1
2
3
4 DRAFT SAFETY EVALUATION BY THE OFFICE OF NUCLEAR REACTOR REGULATION

5
6 TOPICAL REPORT WCAP-16308-NP, REVISION 0

7
8 “PRESSURIZED WATER REACTOR OWNERS GROUP 10 CFR 50.69 PILOT PROGRAM –

9
10 CATEGORIZATION PROCESS - WOLF CREEK GENERATING STATION”

Figure I-1
Risk-Informed Safety Classification
Process

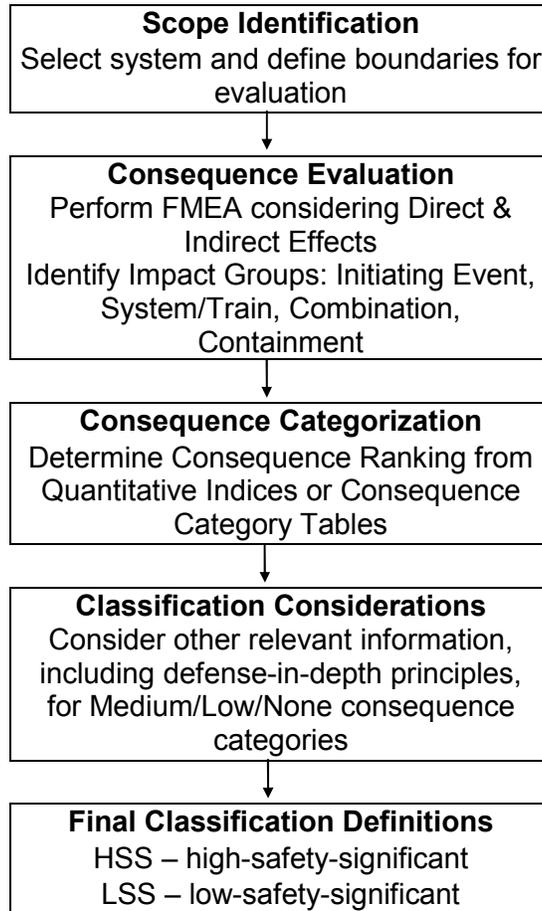
Note 1 – Figure I-1, Risk-Informed Safety Classification Process
